NP-11-0011
April 12, 2011

Subject: Exelon Nuclear Texas Holdings, LLC
Victoria County Station Early Site Permit Application
Response to Request for Additional Information Letter No. 05
NRC Docket No. 52-042

RAI 13.03-1:**Question:****ETE-1: Introductory Materials Related to the ETE Report**

Figure 12: Evacuation Map and Routes

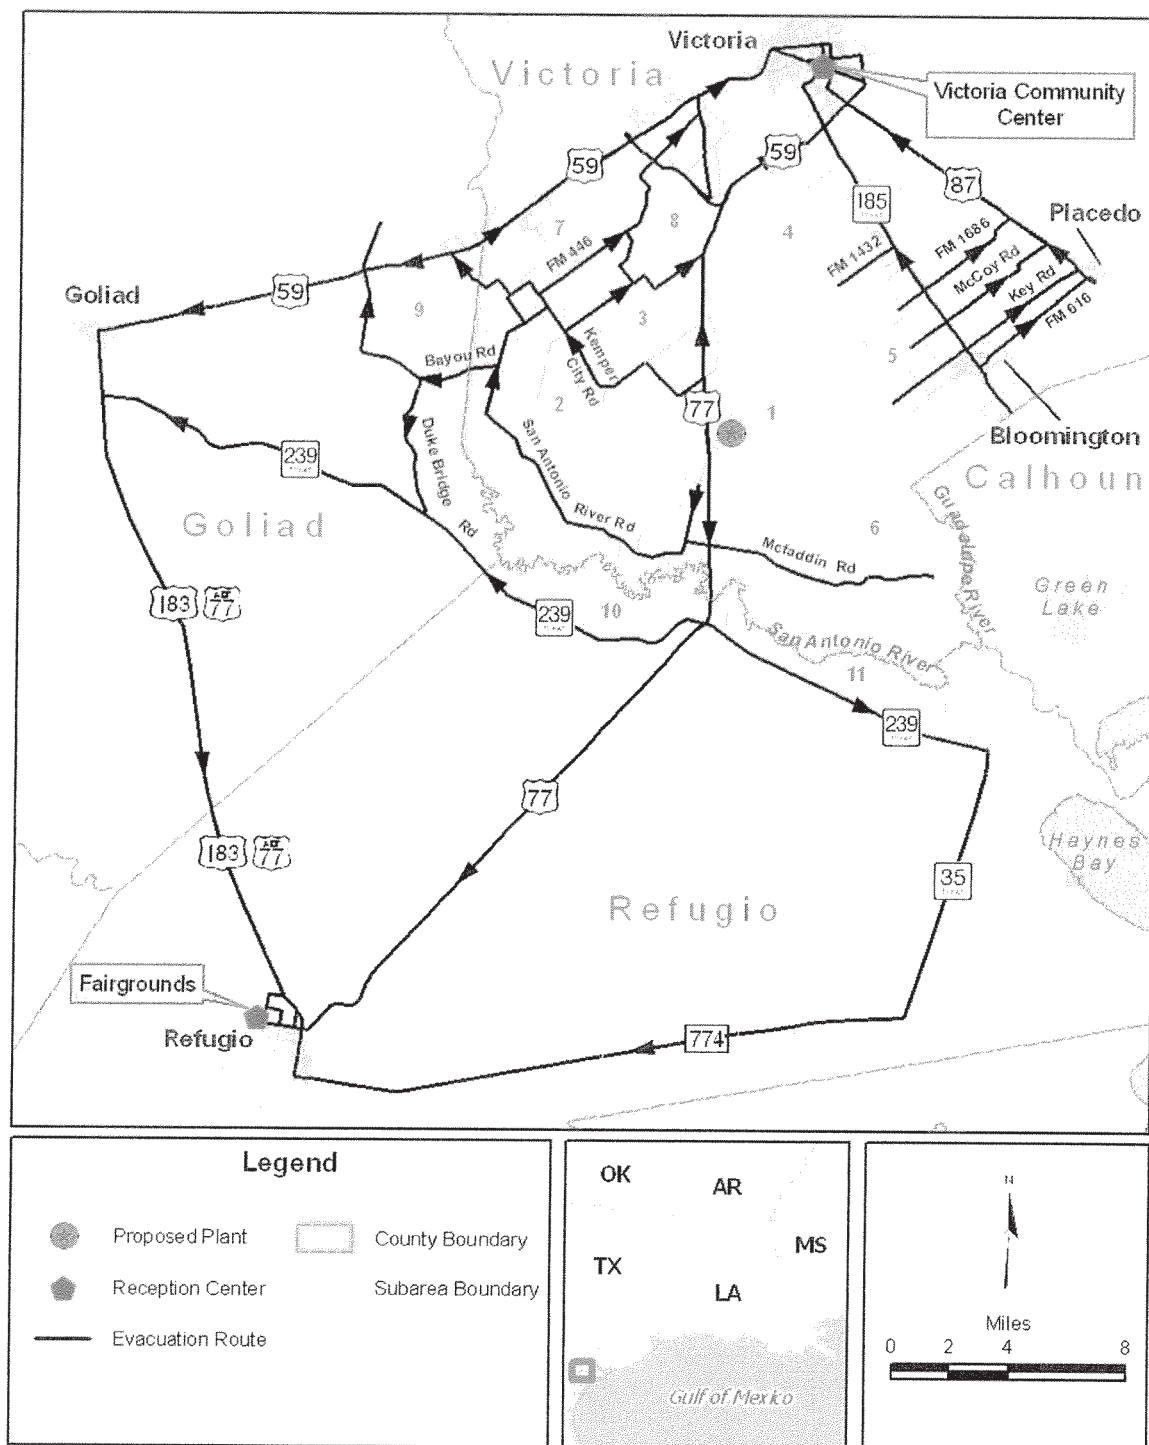
US Highway 77 is identified as an evacuation route in Figure 12, "Evacuation Map and Routes," traversing through the entire EPZ in a northern to southern direction indicating a length of about 20 miles. US Highway 77 is identified in Appendix B, "Evacuation Network Links," as having a length of 6.3 miles. In the ETE Report, discuss why the full length of US Highway 77 was not used in the analysis.

In figure 12, the location where US Highway 77 intersects with US Highway 59 indicates an intersection and a left turn required for travelers to access US Highway 77 to continue north. Aerial mapping shows this intersection to be non-signalized and a free flow under the East Frontage Road (State Road 91) with uninterrupted flow on US Highway 77 in the northerly direction. Discuss in the ETE Report how the crossing of US Highway 77 and US Highway 59 was analyzed.

Appendix B of the ETE report has been revised to incorporate the correct full length of US Highway 77 that comprised part of the evacuation network and was included in the model. The revised ETE Report is provided in Attachment 34.

Figure 14: Evacuation Events and Activity Series for Residences without Family Members Returning Home (Series B)

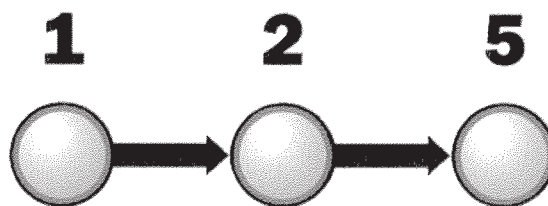
Section 5.1.1, "Trip Generation Events and Activities," states "Figure 14 shows the approach for estimating trip generation for different evacuation activities series." Explain whether this should read "Table 12" rather than "Figure 14" and revise the ETE Report if necessary.

The referenced statement should read "Table 12" and not "Figure 14."

The reference to "Figure 14" has been changed to "Table 12" in Section 5.1.1 of the revised ETE report. The revised ETE Report is provided in Attachment 34.

Figure 16: Notification Times for Selected Alert and Notification Systems³¹

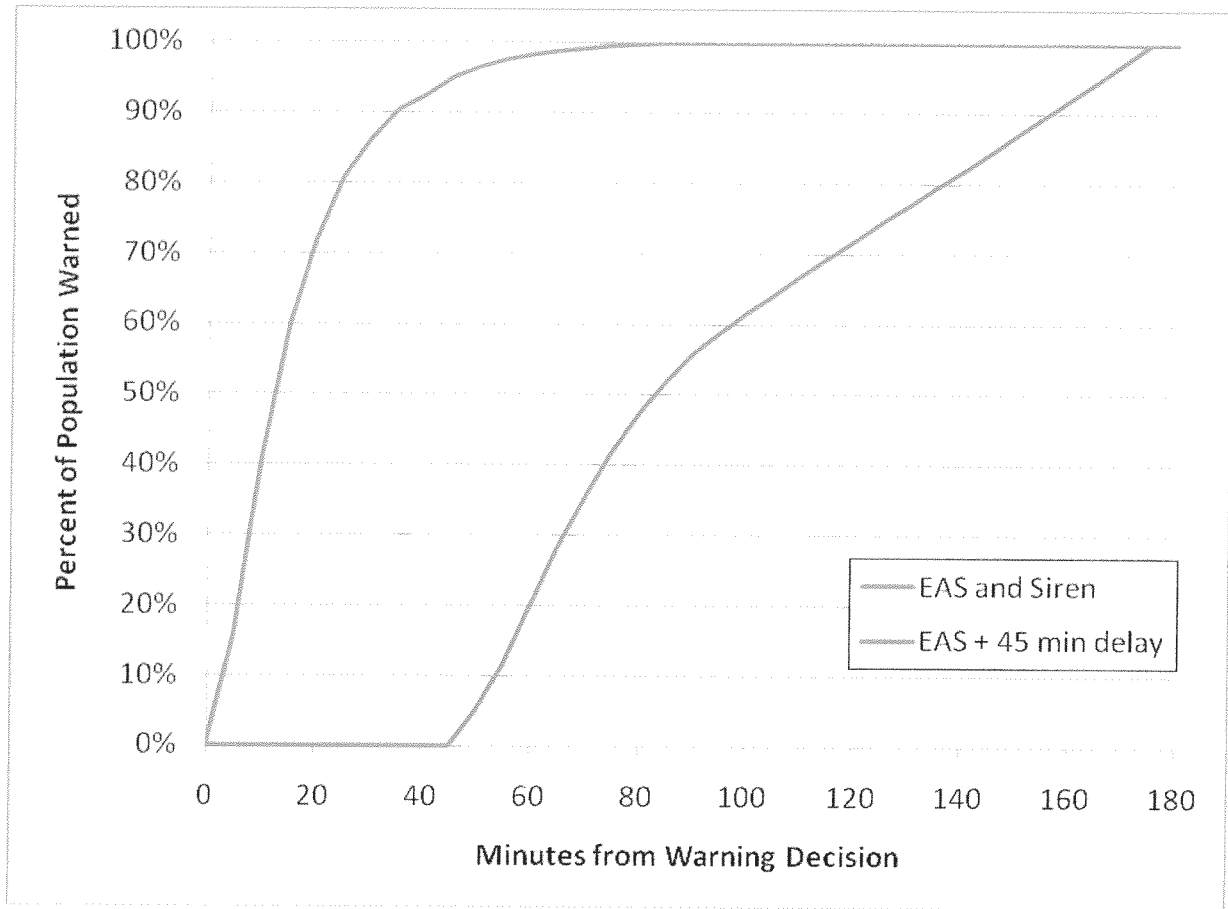
Section 5.1.2, "Trip Generation time Estimate," explains that the time distribution for notification presented in "Evaluating Protective Actions for Chemical Agent Emergencies," (ORNL-6615) was adopted for the ETE study and is presented in Figure 16, "Notification Times for Selected Alert and Notification Systems." In the ORNL-6615 study, Figure 3.4, "Probability of Receiving Warning by Warning System by Time Elapsed Since Warning Decision," shows similar, but not the same information, as Figure 16. For instance, Figure 16 provides data for the combination of EAS and siren systems; whereas, Figure 3.4 provides data for EAS or siren systems, but does not combine the data. Explain how Figure 16 was derived from the ORNL-6615 study to present a distribution of warning time for the combined use of EAS and siren.

The notification time distributions for the warning systems shown in ORNL-6615 (sirens, EAS, and tone-alert radios [TARS]) were developed by measuring and fitting a cumulative distribution function to the curves shown in Figure 3.4 of the ORNL-6615. The notification time distribution for the combination of EAS and sirens was calculated from the individual curves for EAS and sirens using SAS statistical software.⁵ First, one 20,000-entry vector was populated with notification times according to each of the siren and EAS distributions. That is, if, for example, the EAS distribution indicated that 20% of the population would be warned by EAS in the first 15 minutes, the notification times in the EAS vector were selected such that 20% of values were 15 minutes or less. The sirens vector was similarly chosen to match the sirens notification time distribution. These vectors could be interpreted as, respectively, the EAS and siren notification times for 20,000 "people."

The sirens curve was removed from Figure 16 in the ETE report as the distribution was no longer used in the ETE study. However, for completeness, the notification time distribution used for recreational populations (EAS plus 45 minutes) was added to the figure. Figure 16 now includes both notification distributions used in the model.

Figure 22: Map of Evacuation Network Links (from Table 21)

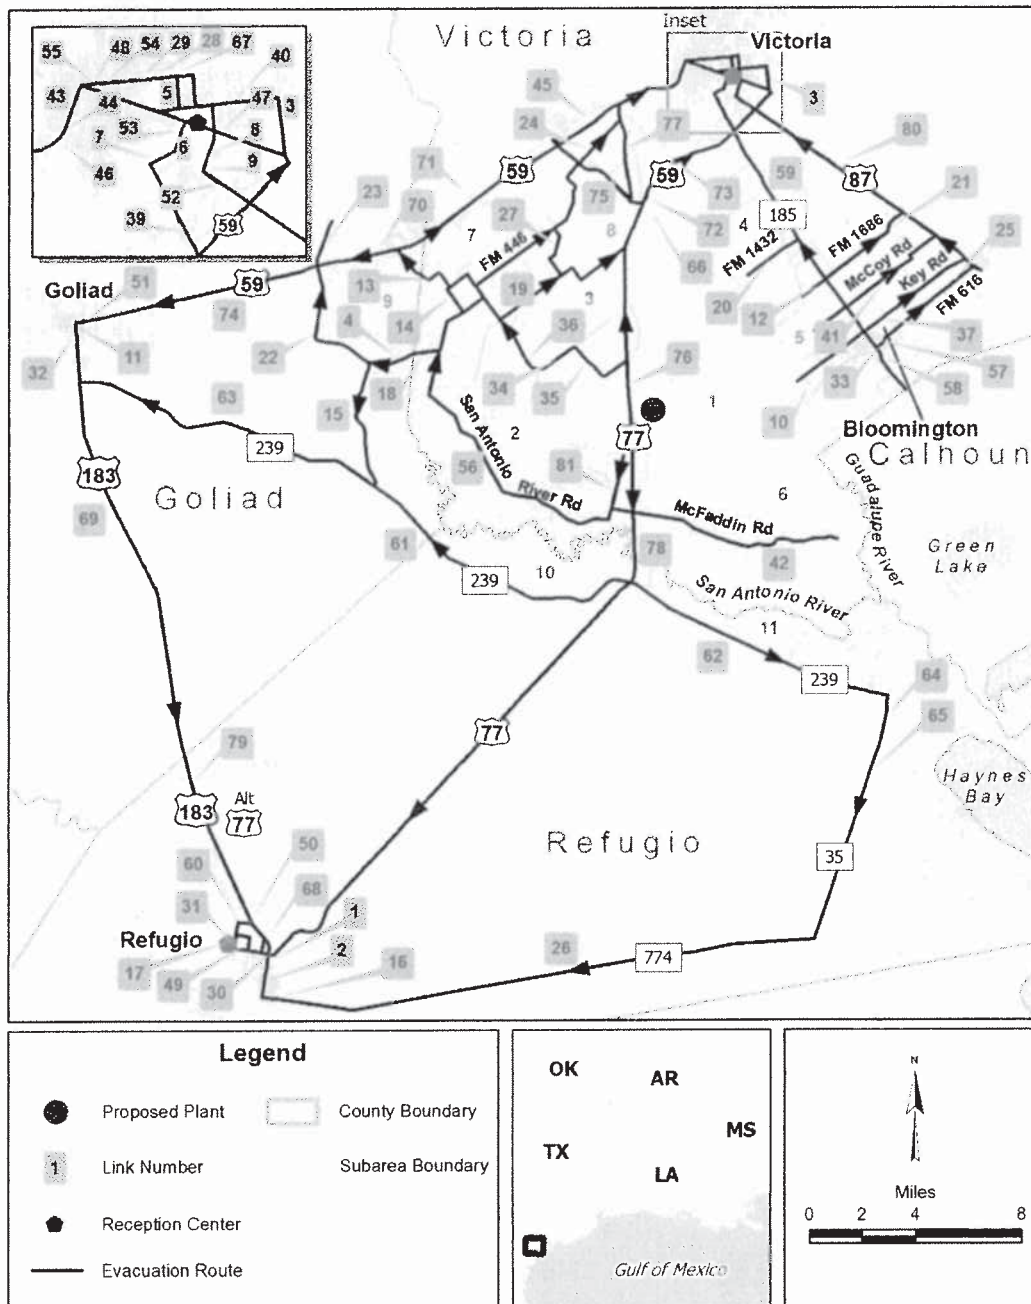
Appendix B, "Evacuation Network Links," lists all of the roadways used as evacuation routes and identifies the number of lanes, length, and speed limit for each roadway segment. In the ETE Report, provide an annotated map of the roadway nodal network that relates to Appendix B roadway segments.

Appendix B of the ETE report has been revised to include an annotated map of the roadway network (see Figure 22).

Appendix B of the ETE report has been revised to include an annotated map of the roadway network (see Figure 22). The revised ETE Report is provided in Attachment 34.
